Re: Response to Sydney North Planning Panel Deferral Notice (PPSSNH-433– DA2023/256)

This letter has been prepared by Gyde Consulting (Gyde) on behalf of Polytec Australia Four Pty Ltd (the Applicant) and responds to the 'Record of Deferral' Notice issued by the Sydney North Planning Panel (the Panel) dated 25 June 2025 in relation to the proposed Development application (DA-2023/256) at Nos 629-639 Pacific Highway, Chatswood.

Table 2 Privacy comments and response

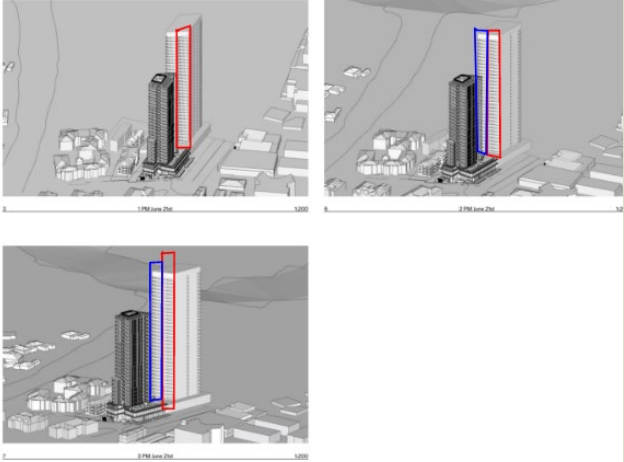
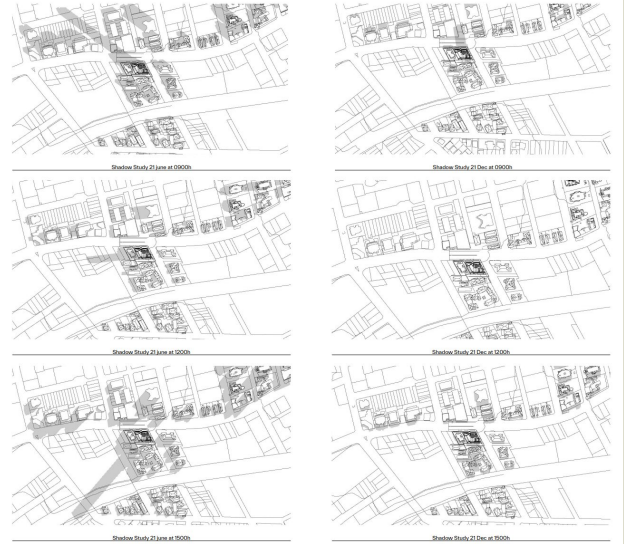
Council's comments	Applicant's response
A public submission from Nos. 613 & 621-627 Pacific Highway, Chatswood, raised concerns regarding privacy along the property. The submissions requested that the proposed privacy screens to be extended around the south-western corner for a minimum of 1 metre along the Pacific Highway elevation, on balconies with an outlook to Nos. 613-627 Pacific Highway. Council staff requested additional details at either a 1:20 or 1:50 scale so that the effectiveness of the privacy screen could be assessed.	As addressed in the SNPP Planning Panel letter dated 23 June 2025, the future development on Nos. 613-627 Pacific Highway, Chatswood, is not approved and by all accounts appears to be very much in its infancy in terms of design details and the progression of the SSDA. The future development should not be used as a determinative reference point for the redesign of aspects of the proposed development. Notwithstanding this concern, we indicated in our previous response that we would be satisfied with the imposition of a condition that addressed the increased length of privacy screens/blade walls on west-facing balconies where relevant to address privacy concerns. Privacy of the neighbouring property is currently maintained with the provisions of the separation distance provided (6m), green roof and planter beds. Collectively, these design features adequately maintain a physical separations and privacy between both sites. The extension of the privacy screens/blade walls (if conditioned and incorporated) would assist in maintaining visual privacy between development. In general, the design seeks to protect the privacy of its occupants and the future occupants of the adjoining building, evident with: - The proposed development is generally compliant with the recommended design criteria in relation to visual privacy within the ADG. - Windows, balconies and terrace areas of the upper-level apartments designed to prevent overlooking of the adjoining properties. - The proposed development is sufficiently separated from adjoining sites and adjoining development.

Table 3 Solar Access comments and response

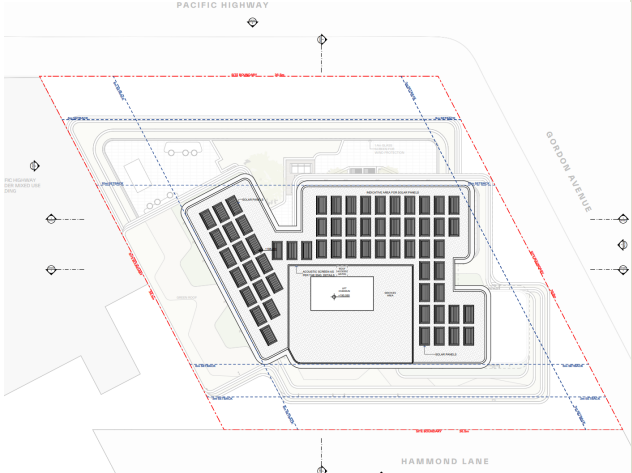
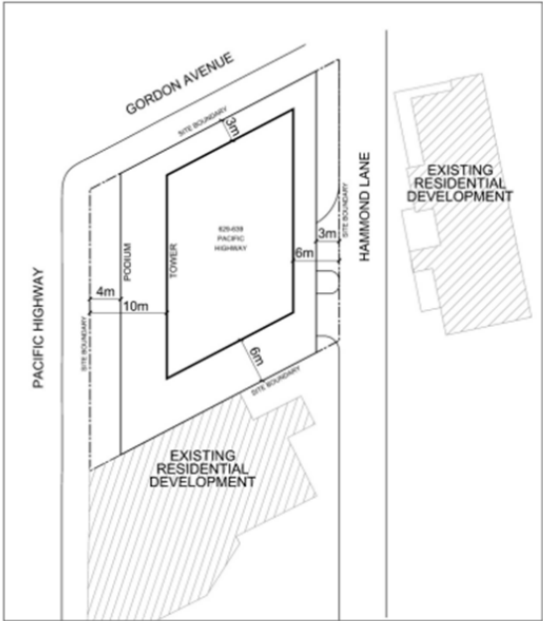
Council's comments	Applicant's response
A public submission from Nos. 613 & 621-627 Pacific Highway, Chatswood, raised concerns regarding solar access to the future mixed-use development proposed for the site (SSD-73505961), and the potential overshadowing impacts of the proposed development.	Solar access and shadow diagram with the indicative residential tower proposed in Nos. 613-627 Pacific Highway, Chatswood, have been prepared by PBD Architects (see attached Appendix K – Solar Access and Shadow Diagrams). The outcome of the analysis

Council's comments	Applicant's response
A request was made within the submission for updated solar access analysis and shadow diagrams that included an analysis of the impacts to the indicative residential tower proposed in Nos. 613-627 Pacific Highway, Chatswood, Planning Proposal (PP-2021-2923) Council requires the applicant to prepare an analysis that clearly illustrates the shadow impact at 30-minute intervals between 9am – 3pm on 21 June, to confirm that the proposal does not unreasonably impact Nos. 613 & 621-627 Pacific Highway in its ability to achieve the minimum ADG solar access requirements.	demonstrates that the indicative residential tower proposed on the neighbouring site can achieve the minimum ADG solar access requirements (minimum 2-hours direct sunlight between 9 am and 3 pm at mid-winter). The figure below provides a high level visual illustration of the solar access received by apartments situated on the northeastern corner of the indicative development (highlighted in Blue in Figure 1 and 2).  Figure 1 Solar Analysis 613-627 Pacific Highway 9am-12pm June 21st (Source: PBD Architects, edited by Gyde Consulting) Apartments with balconies and windows situated on the northeastern corner of the indicative development proposed on Nos. 613-627 Pacific Highway, will achieve a minimum 2 hours of direct sunlight (9am-10am & 2pm-3pm). Apartments with balconies and windows situated on the northwestern corner of the indicative development will achieve a minimum 2 hours of direct sunlight from 1pm-3pm. The figure below provides a high-level visual illustration of the solar access received by apartments situated on the northwestern corner of the indicative development (highlighted in Red in Figure 2).

Council's comments	Applicant's response
	 Figure 2 Solar Analysis 613-627 Pacific Highway 1pm-3pm June 21st (Source: PBD Architects, edited by Gyde Consulting) The shadows cast from the amended development are considered an expected impact given the proposed development is compliant with the height and relevant WDCP building controls. Accordingly, the overshadowing impacts are acceptable as it is anticipated as part of the controls. Shadow analysis of the proposal's impact at various intervals between 9.00am and 3.00pm mid-winter are provided in Appendix K.  Figure 3 Shadow Diagrams (Source: PBD Architects) It should be noted that the indicative built form used to illustrate the proposed development on Nos. 613-627 Pacific Highway, Chatswood is still in its concept design stage and is therefore subject to change.
